Delegated Report

Full Planning Application

Application No:	20211121
Location:	1 Codrington Gardens, Gravesend, Kent, DA12 5DB
Description:	Erection of an attached 3 bedroom house in the side garden of the existing dwelling house and provision of off street car parking.
Applicant:	Mr Hardeep Singh
Site Visit:	N/A Desktop Assessment

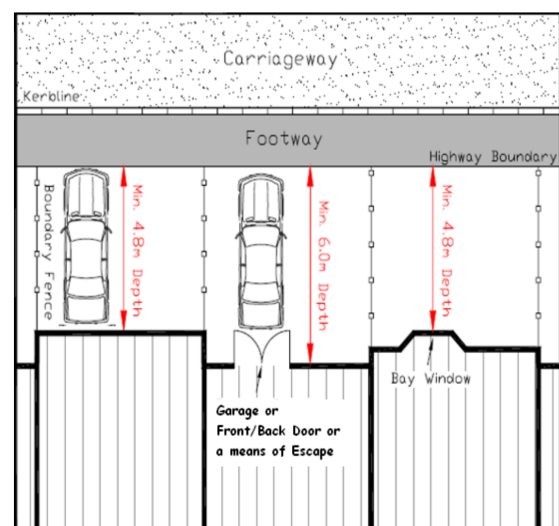
GBC Highways Officer - I find this application confusing as the property has a carriage crossover and parking in the front garden, but the installation does not confirm to the requirements of the highway authority.

The Design and Access statement also shows the carriage crossover with the access not having the benefit of pedestrian visibility splays and the drive appears to be constructed from loose stone, but possibly a bound gravel. If the drive is in loose stone, both are not acceptable in highway terms as the lack of a pedestrian visibility splay puts pedestrians at risk, whilst a loose stone construction runs the risk of materials being dragged onto the highway.

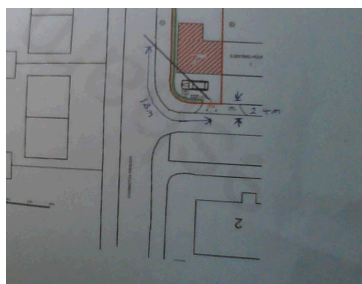
Looking at the application. The Kent County Council publication; Vehicle Crossing: - Guidance and Self Assessment states that carriage crossovers should be a minimum of 10 metres from a junction

The proposed extended crossover is considerably closer than ten metres. In addition, being a new property its parking provision should conform to current guidance, which requires the parking to be perpendicular to the highway

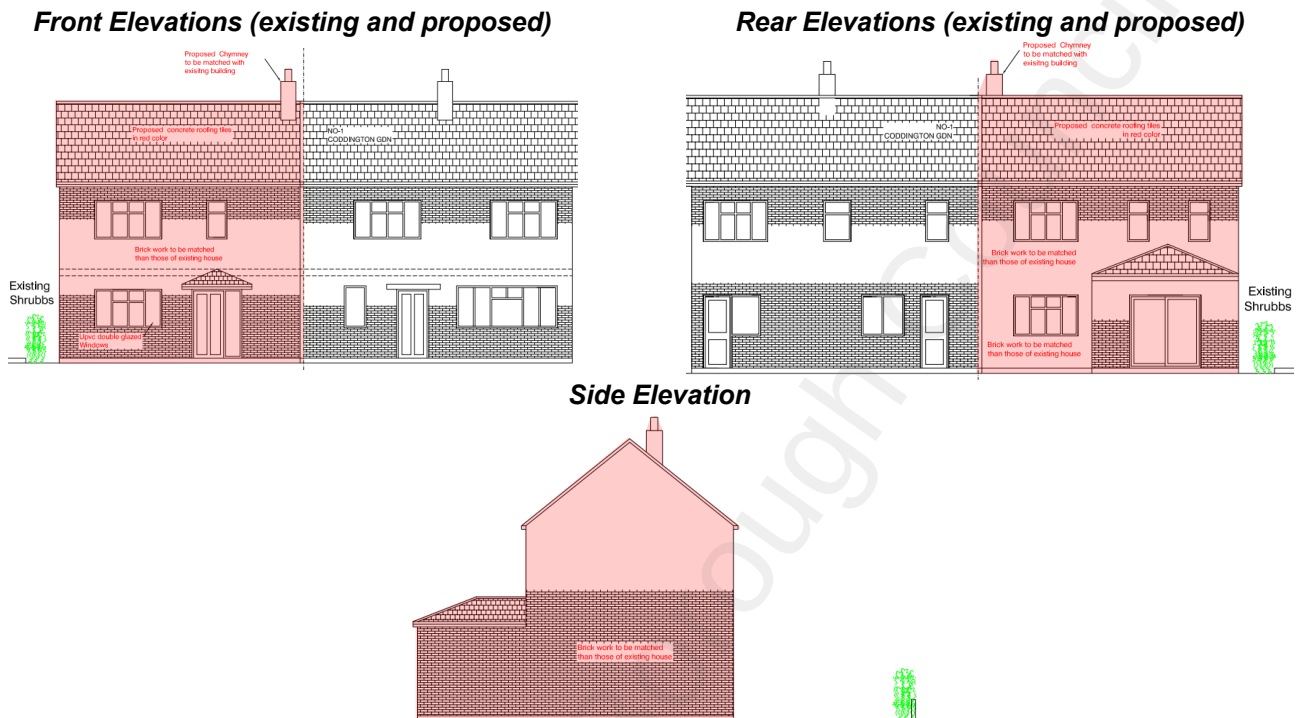
The curtilage of the property has been annotated onto a google maps satellite image to show the extent of the curtilage, the driveway arrangement and garage. The property has mature hedging along the boundary and has substantial soft landscaping, trees and shrubs within the garden area.

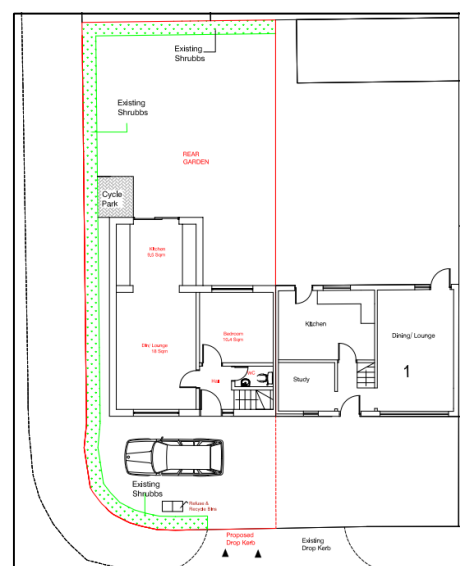
The screenshots below demonstrate the proposed dwelling (red) and allow for a comparison with the existing property.

The proposed dwelling complies with Gravesham's Residential Layout Guidelines (RLG) (2020) and all habitable rooms will be served by windows, receiving adequate natural light. The garden space has a maximum depth of 11.6m and an area of 82m², which comply with Gravesham's RLG for a three bedroom dwelling.

However, the new dwelling will be overlooked by the adjoining property at the rear, no.64 Wilberforce Way. Gravesham's RLG states that the minimum window-window distance for habitable rooms should be 26m when over private garden area. In this case, the window-window distance is 21.5m. As such the private amenity space of the new dwelling will be overlooked by the adjoining property and is considered to provide poor quality. Even though the amenity space of the existing property is similarly overlooked by no.64 Wilberforce Way, the policy guidance was
